ECO No. N0012

NABU ENGINEERING CHANGE ORDER

PRODUCT LINE	AFFECTED ITEM(S)	RELATED ECO
1600	MAIN LOGIC BOARD 90000420	-

To modify the floppy disk interface to add write precompensation circuitry.

HLT
VCO
2793
U79
8255
U78
U82
LS123
U85
U102
U49
U137
U101
LS157
U135
LS74
U136
LS193
U120
Y2
8 MHz
J6
ECO # N00178
PAGE 6 OF 12
Change to
APPROVED W. SIM
CHECKED S. CHOW
SIZE D

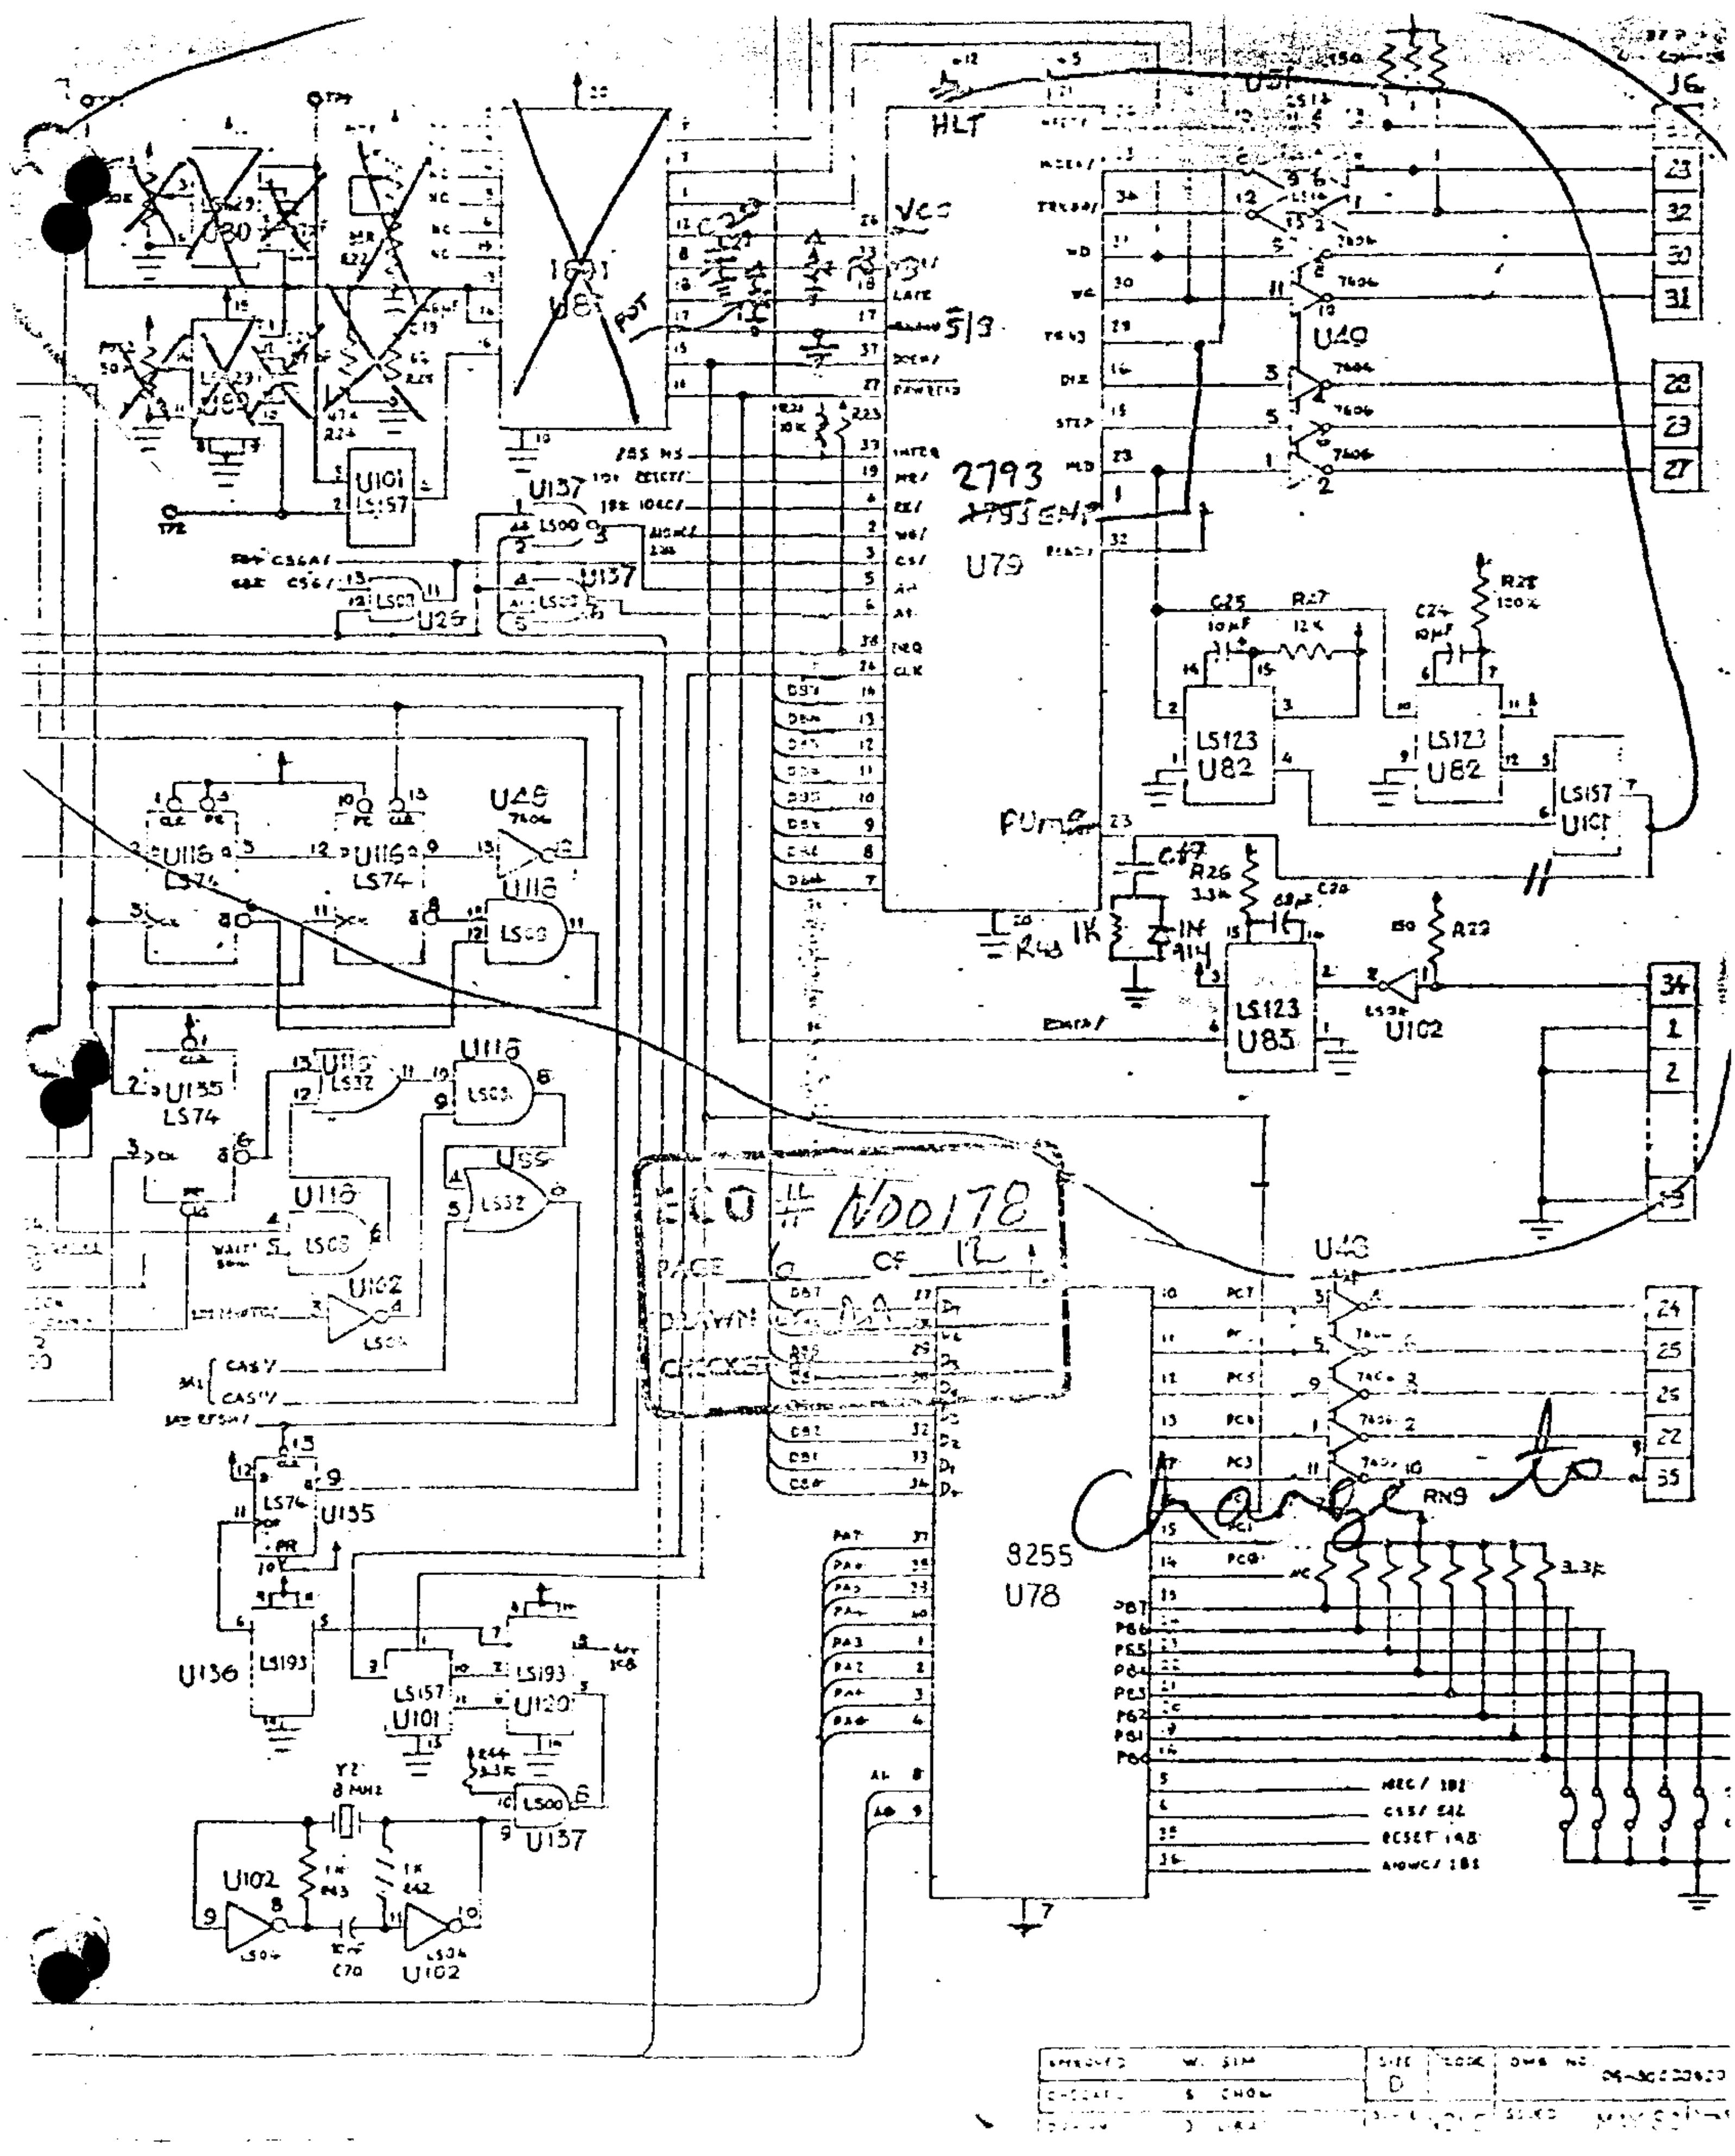
DOCUMENT No.	REVISION OLD	REVISION NEW	DOCUMENT TITLE	DETAILS OF CHANGE (REFER ALSO TO ATTACHED SHEETS)
9,000,042,0-01,0	.05	.06	BOM	CHANGE BOM AS PER SHEETS 2-4
9,0,0,0,0,4,2,0-,06	.03	.04	LOGIC	CHANGE LOGIC AS PER SHEETS 5 & 6 UPDATE
				PAGE 1 APPROPRIATELY.
9,0,0,0,0,4,2,0,-,08	.04	.05	ASSY DWG	UPDATE ASSY DWG TO INCLUDE ALL CHANG
90,000,4,2,0,-,4,0	.03	.04	BLANK	UPDATE P DWG APPROPRIATELY SEE SHEET
9,0,0,0,0,4,2,0,-,4,2	.03	.04	P DWG	REWORK ALL BLANKS AS PER SHEET 8
				FOR ADJUSTMENT PROCEDURE SEE SHEET 7

PWA
CPU MAIN LOGIC

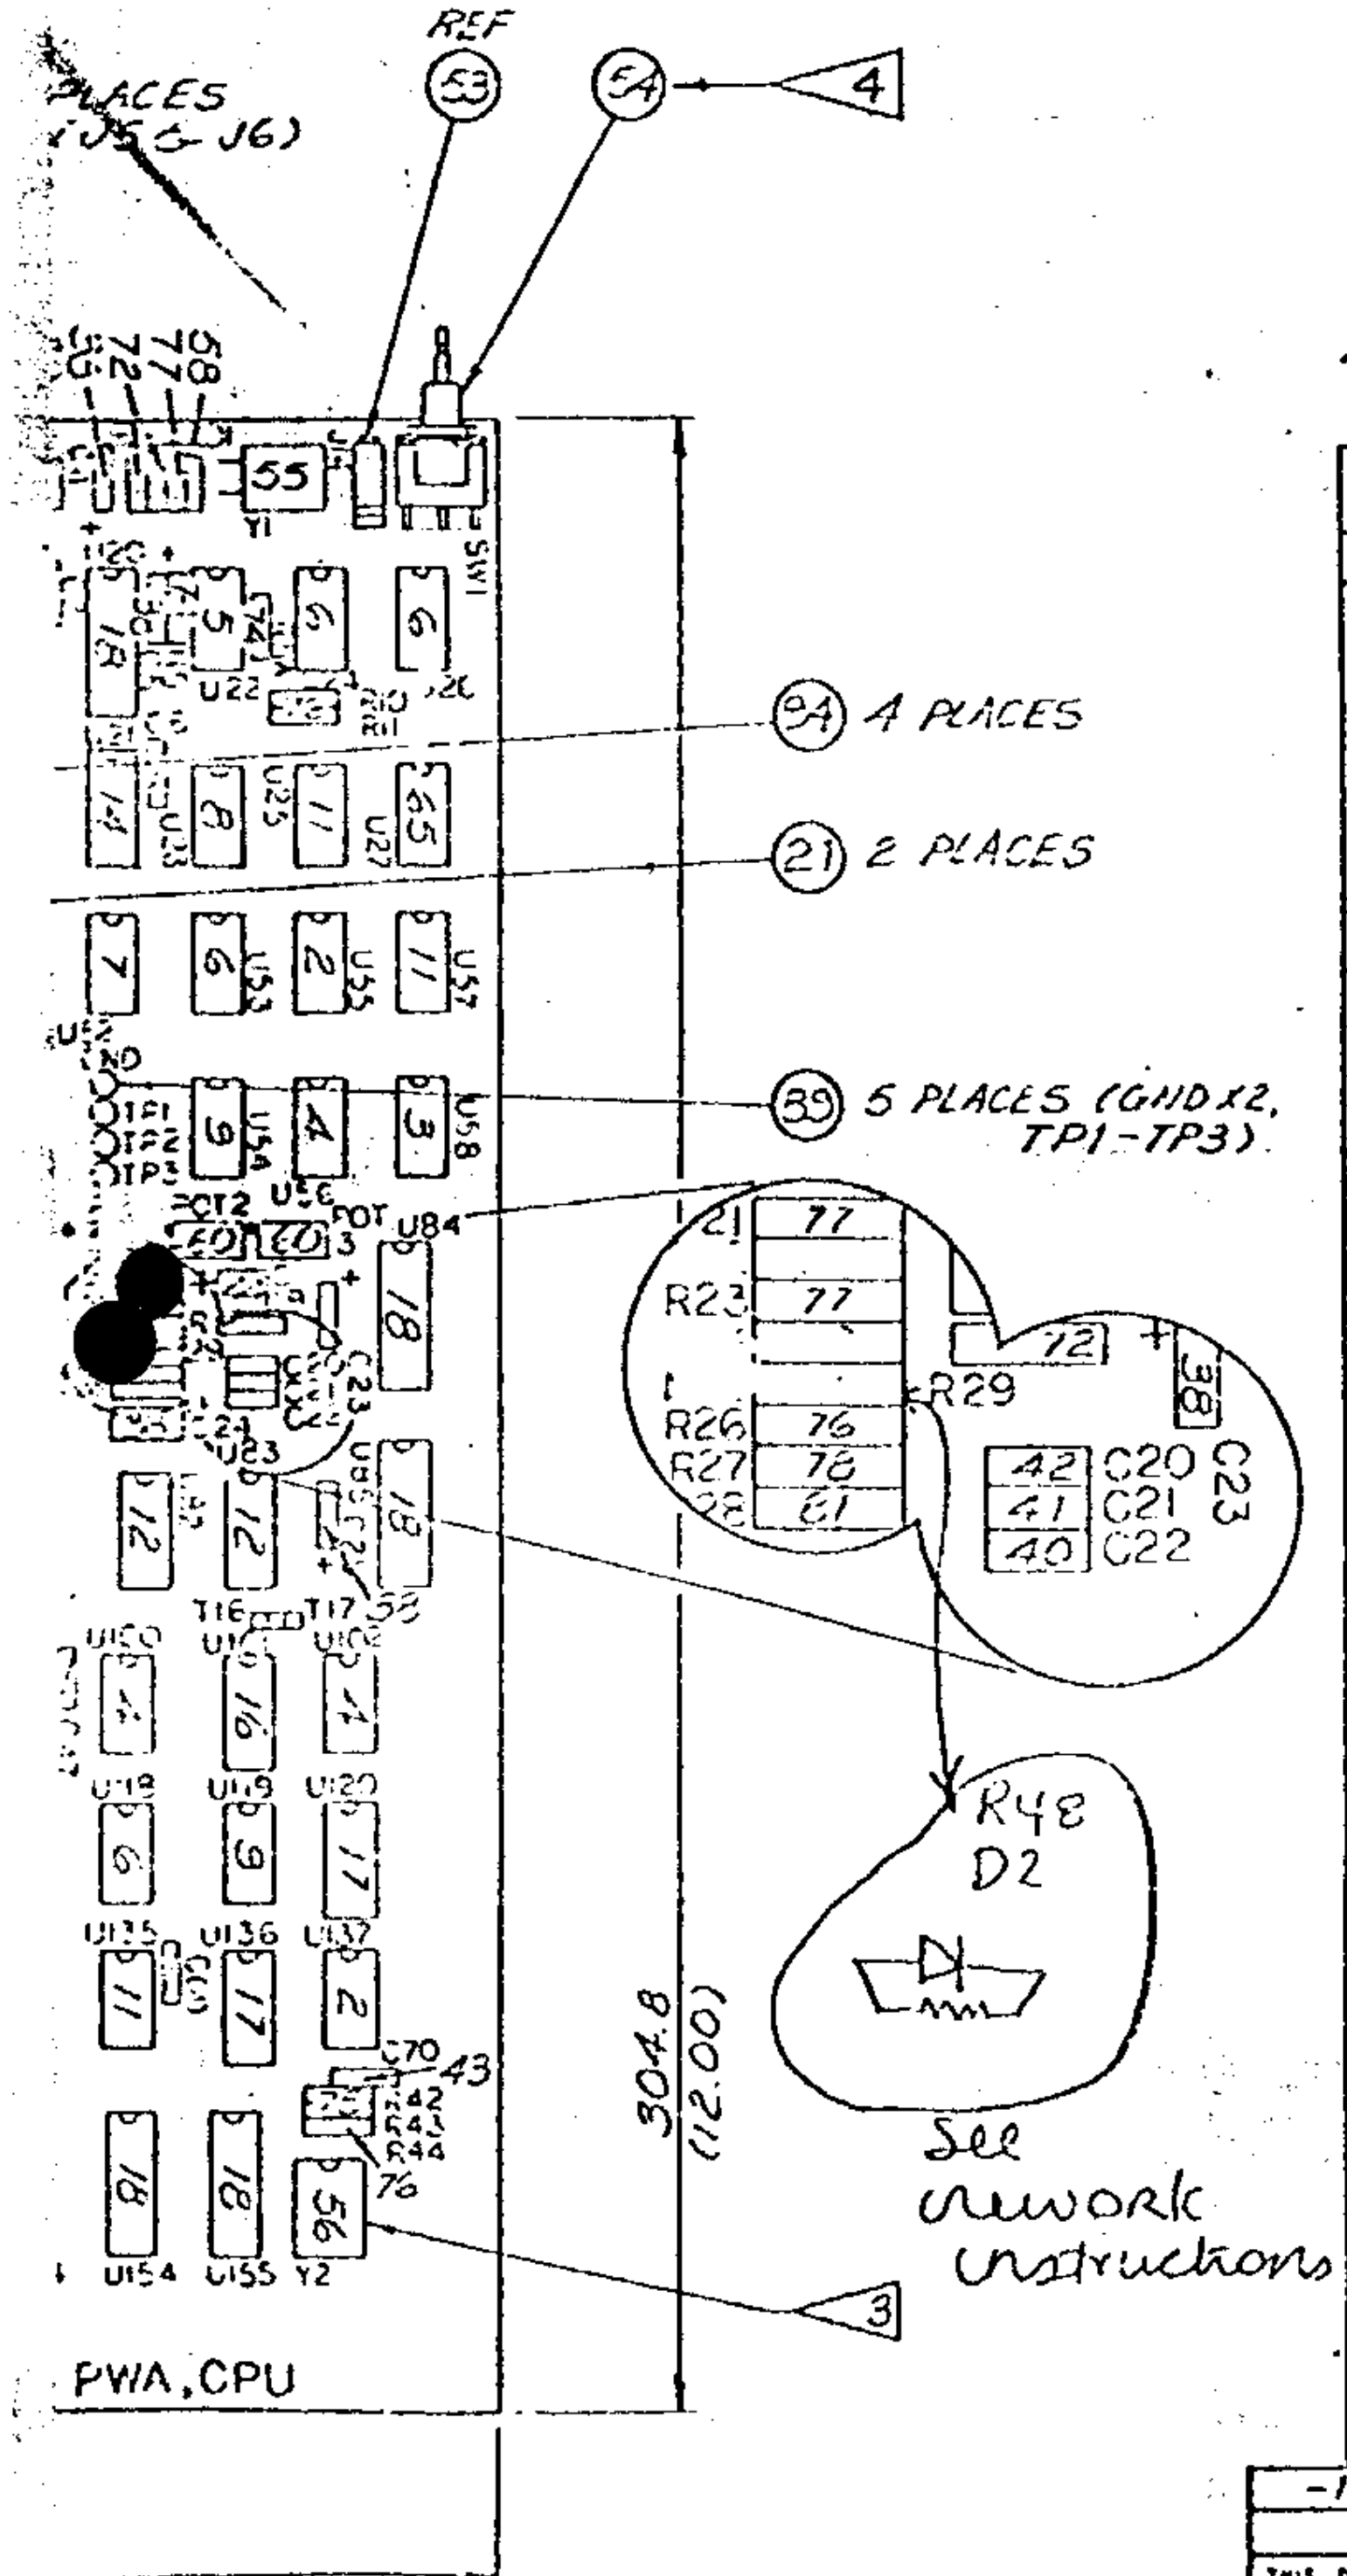
assembly drawing to reflect logic & BOM changes

TO DRAFTING: THIS IS THE EQUIVACENT SCHEMATIC OF THE LOGIC WITH ECO N00178 AND THIS ECO ON THE PWA

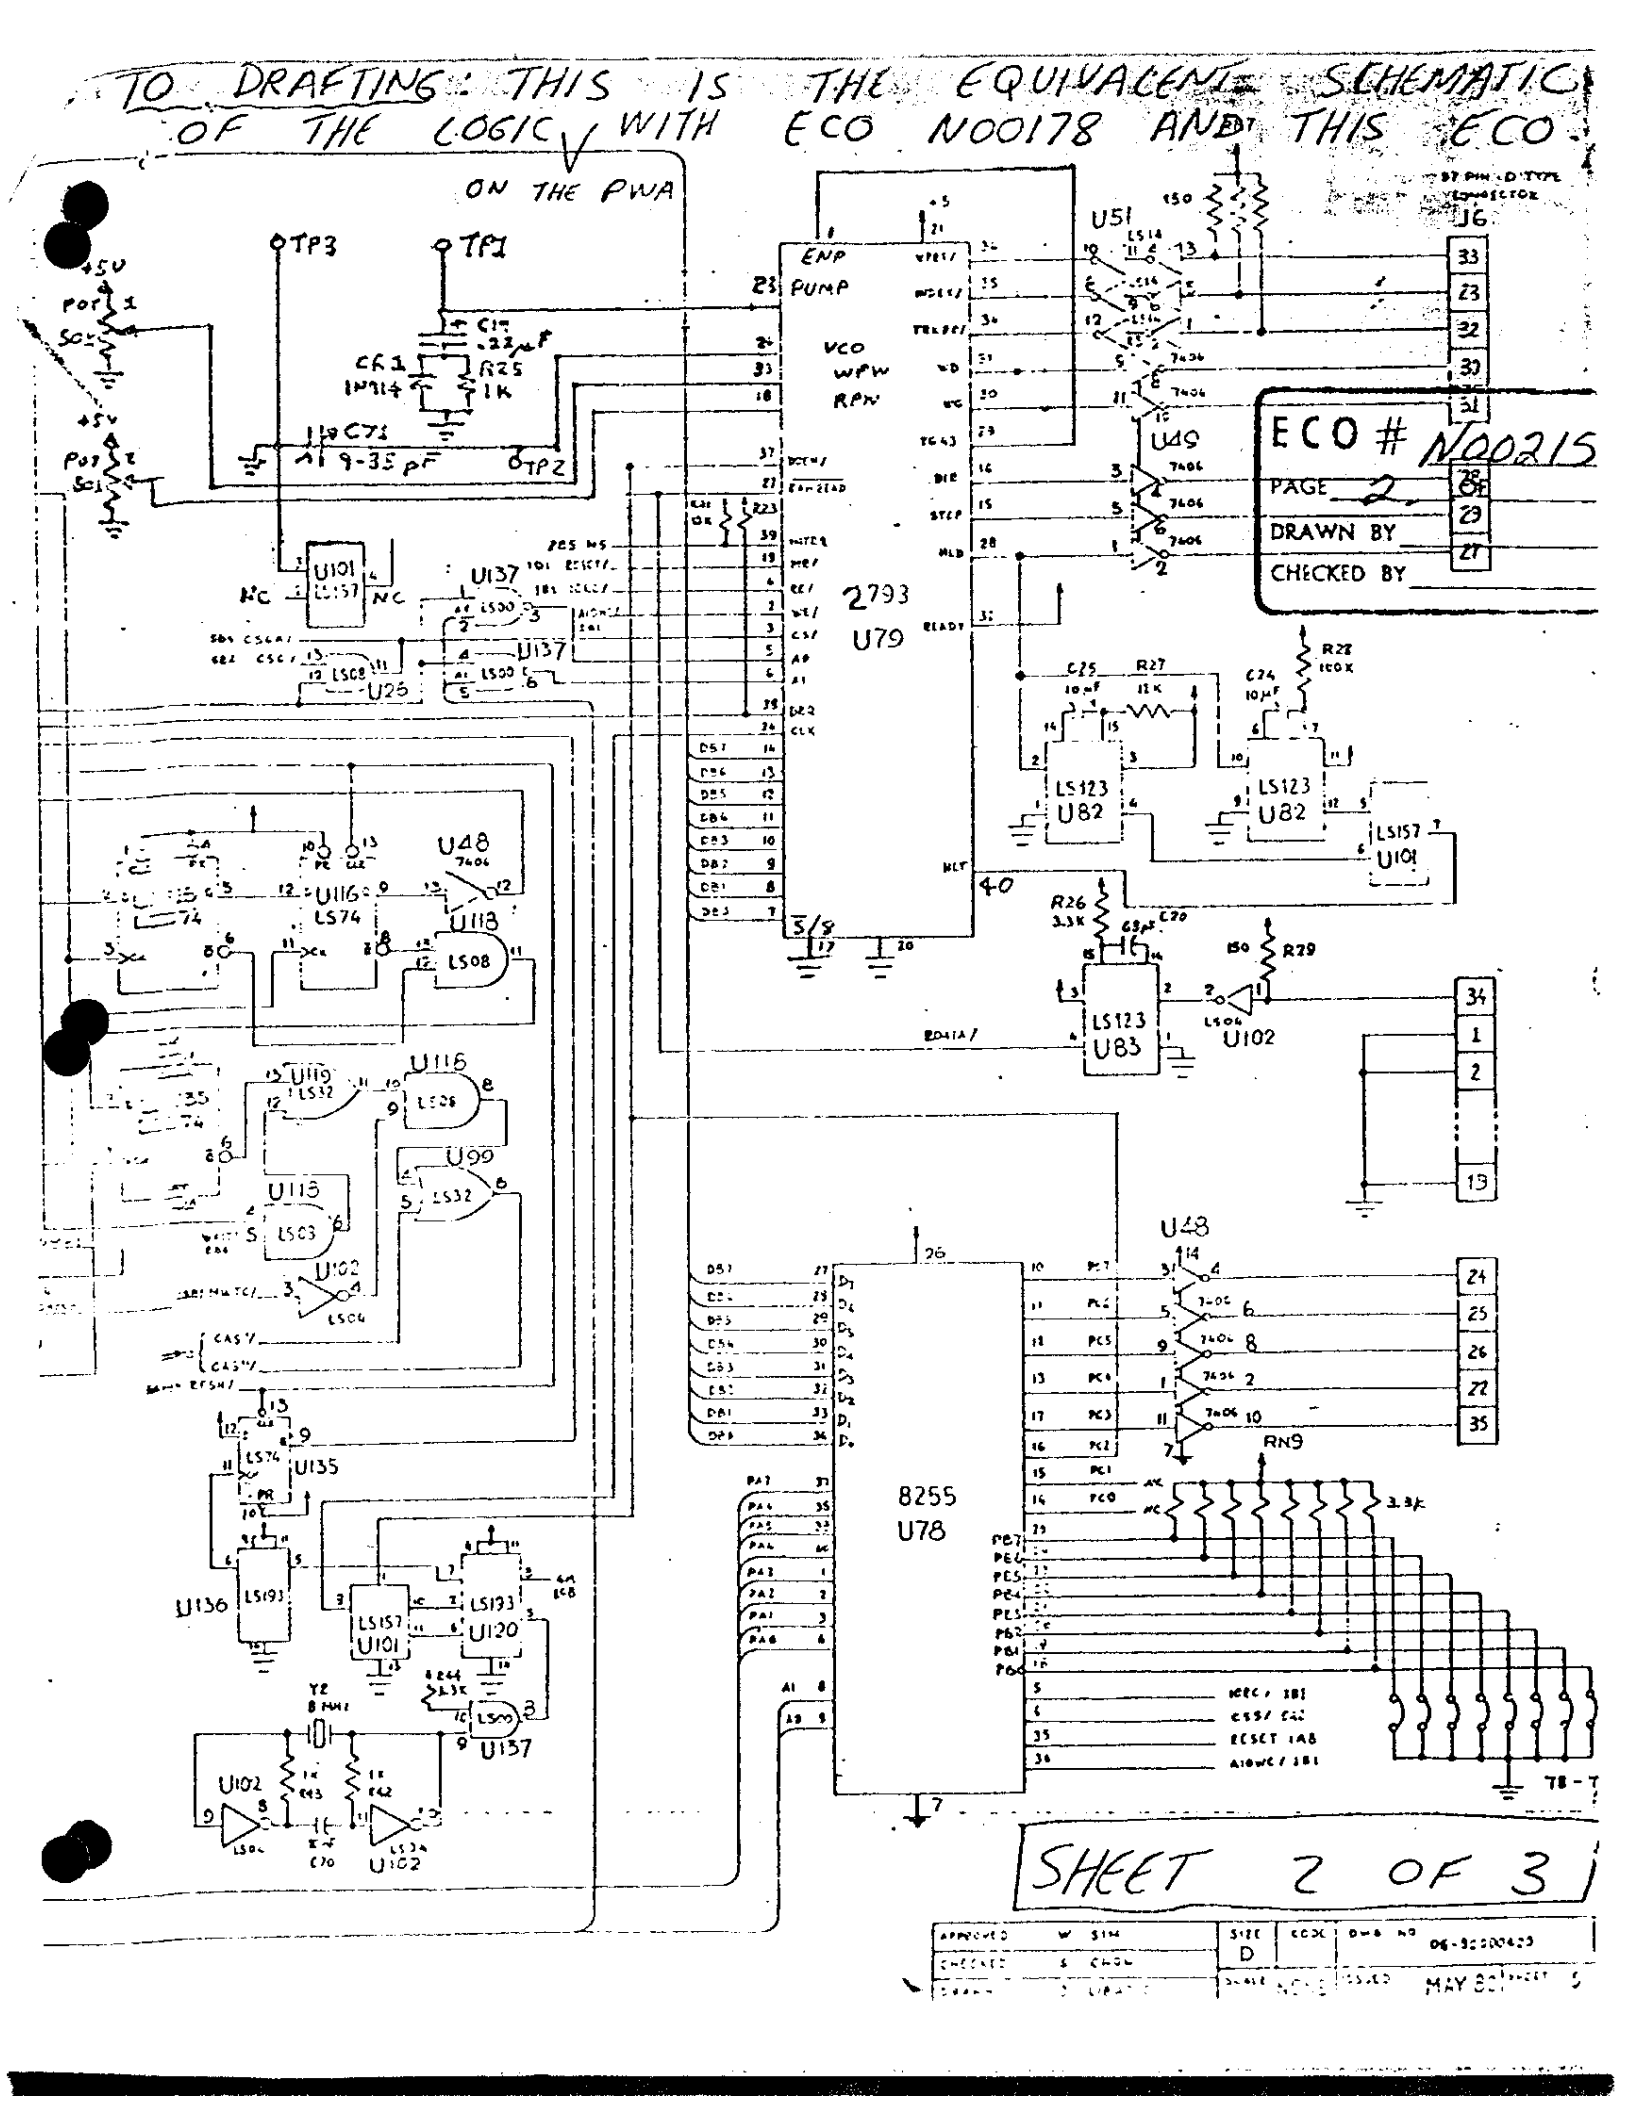
TO CORRECT ECO N00178. THIS ECO ELIMINATES CALIBRATION PROBLEM OF 2793 VCO.

1. CUT TRACK ON COMPONENT SIDE AT U101.2.
